Access Compliance Report

Public Rights-of-Way

(Curb Ramps)

Intersection ID: 14212	Main Street: HAWKINS_ST	Cross Street: W_TREMONT_AV	Location: NE
ADA ID: E81A883A07FC	Ramp Type: PerpDiag	Initial Pass/Fail: Fail	Overall Compliance: No
Severity Score: 26.25			
Codes/Mitigation Info/Possible Solution		Field Measurements/Component Compliance

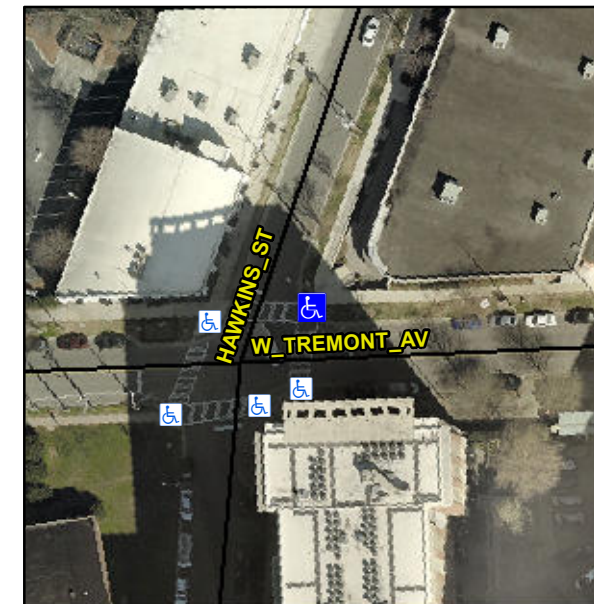
R304.2.2, R304.5.3

Compliance	Description	Data	Compliance	Description	Data
N/A	Ramp Length (in)	74.0	No	Ramp Slope (%)	13.0
Yes	Ramp Width (in)	72.0	No	Ramp XSlope (%)	2.1
N/A	Flare Type LT	N/A	N/A	Flare Type RT	N/A
N/A	Flare Slope LT (%)	N/A	N/A	Flare Slope RT (%)	N/A
N/A	Flare Traversable LT?	N/A	N/A	Flare Traversable RT?	N/A
N/A	Landing Length (in)	N/A	N/A	DWS Provided?	N/A
N/A	Landing Width (in)	N/A	N/A	DWS Contrast?	N/A
N/A	Landing Slope (%)	N/A	N/A	DWS Length (in)	N/A
N/A	Landing X Slope (%)	N/A	N/A	DWS Full Width?	N/A
N/A	Landing Curb? (Y/N)	N/A	N/A	DWS Offset (in)	N/A
N/A	Shared Landing?	N/A			
N/A	Gutter Ponding?	N/A	N/A	Gutter Slope (%)	N/A
N/A	Gutter Lip Ht (in)	N/A	N/A	Gutter X Slope (%)	N/A
N/A	Painted X Walk1?	No	N/A	Painted X Walk2?	Yes
	X Walk 1 Direction	To W		X Walk 2 Direction	To SW
N/A	X Walk 1 Width (in)	N/A	N/A	X Walk 2 Width (in)	114.0
	X Walk 1 Slope (%)	2.8		X Walk 2 Slope (%)	5.3
	X Walk 1 X Slope (%)	5.6		X Walk 2 X Slope (%)	5.0

N/A	Ramp inside XWalk1?	N/A	N/A	Ramp inside XWalk2?	Yes
	Road Slope (%)	6.7	N/A	Clear Space?	N/A
	Road X Slope (%)	1.9	N/A	Clear Space to XWalk (in)	N/A
N/A	Any Obstructions?	N/A	N/A	Storm Grate/Utility Hazard?	N/A
	Obstruction Type			Storm Grate/Utility Type	
		N/A			N/A
		Yes		Surface Condition? (G/P)	Good

Remove & Replace Curb Ramp With Two New Directional Ramps or Equivalent.
